# **Coordinator-General's evaluation report for an environmental impact statement**

## **Northern Pipeline Interconnector – Stage 2 Project**

**November 2009**

# Northern Pipeline Interconnector – Stage 2 Project

**Figure 16 Typical corridor width construction requirements**

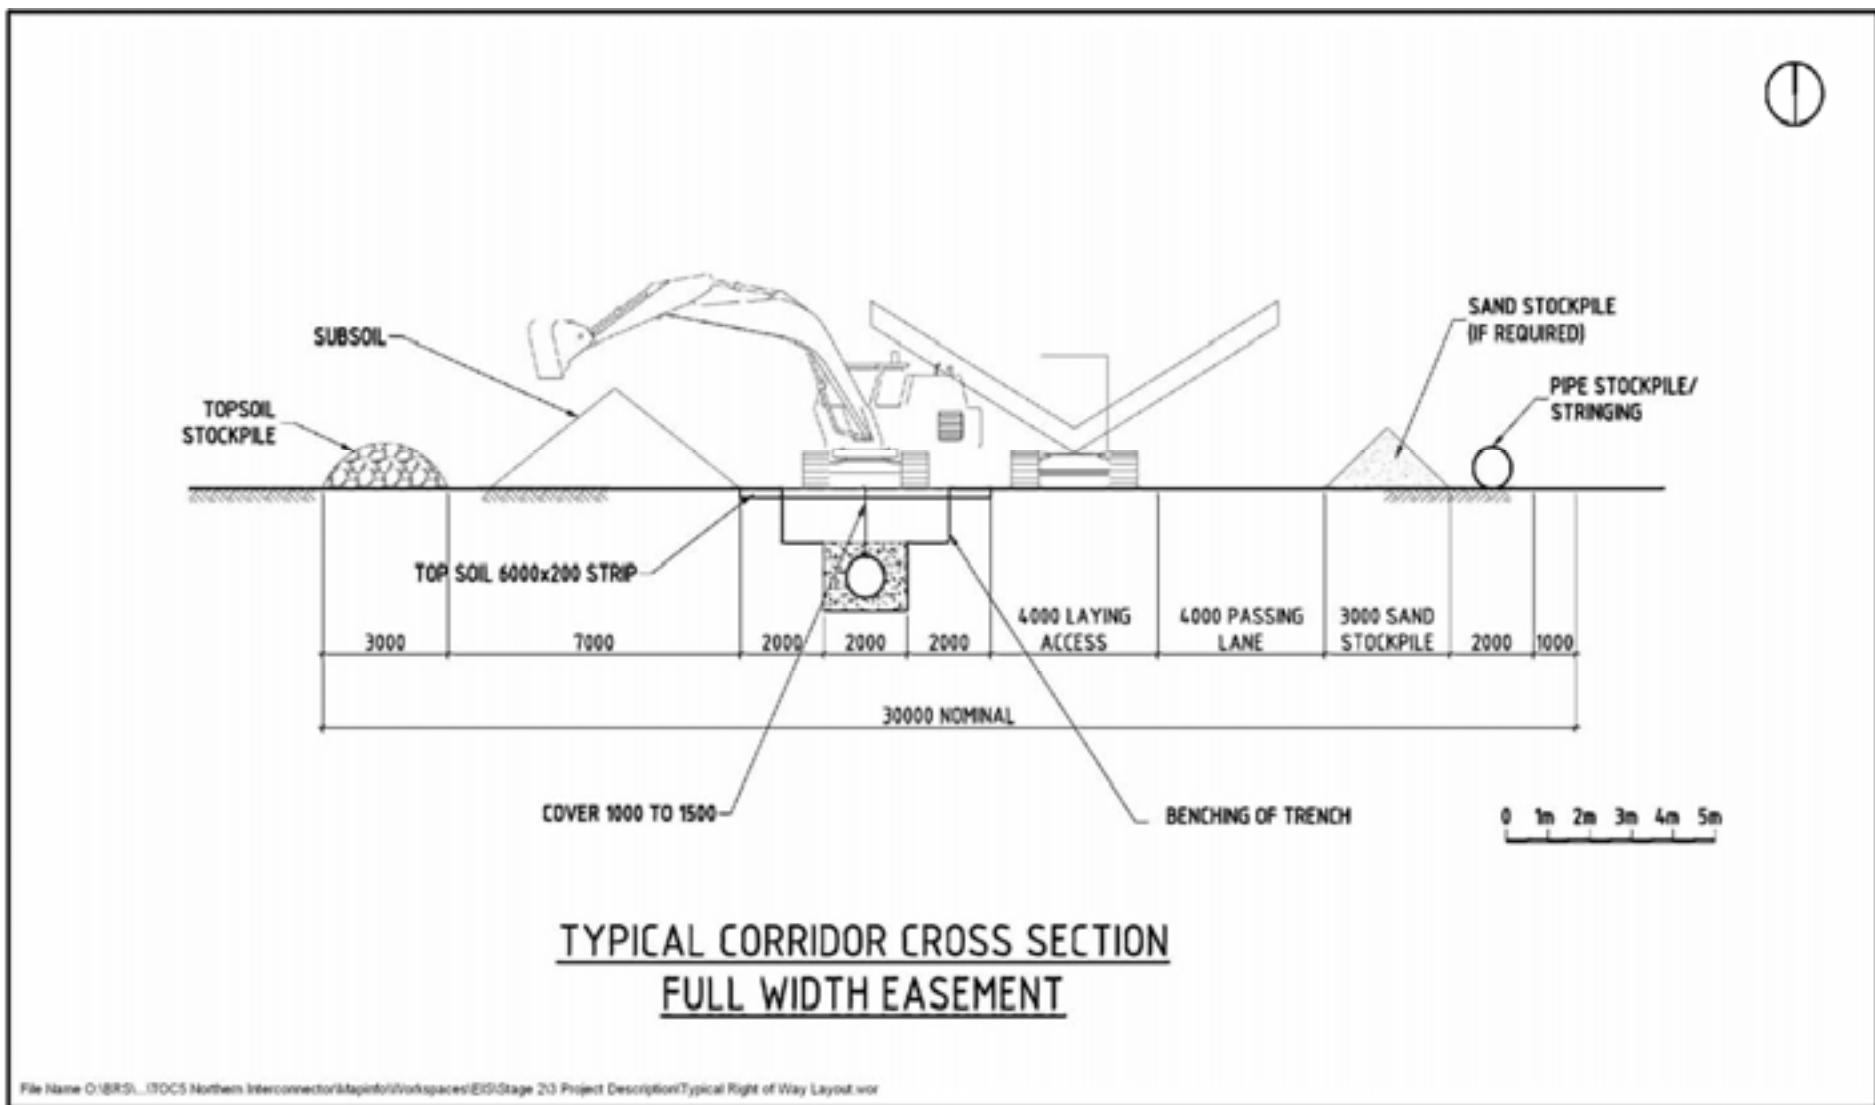
I have also formed the view that corridor clearing for non-environmentally sensitive areas, those that I have not restricted to 10 m, is not to exceed 20 m in width. I have formed this view informed by advice provided by LinkWater Projects within the EIS as included in this report at Figure 16 – Typical corridor width construction requirements which indicates that a 20 m width is sufficient to allow for construction activities. I acknowledge that this will require additional transportation rather than stockpiling, however, as a majority of the corridor has already been cleared to a width of 40 m this will allow for sufficient stockpiling adjoining those areas which have been constrained to 10 m or 20 m. To avoid any misunderstanding, clearing of regrowth that is under 3 m in height is acceptable.

In order to minimise impacts to sensitive regional ecosystems and to manage unavoidable impacts associated with the clearing of vegetation, I require the following:
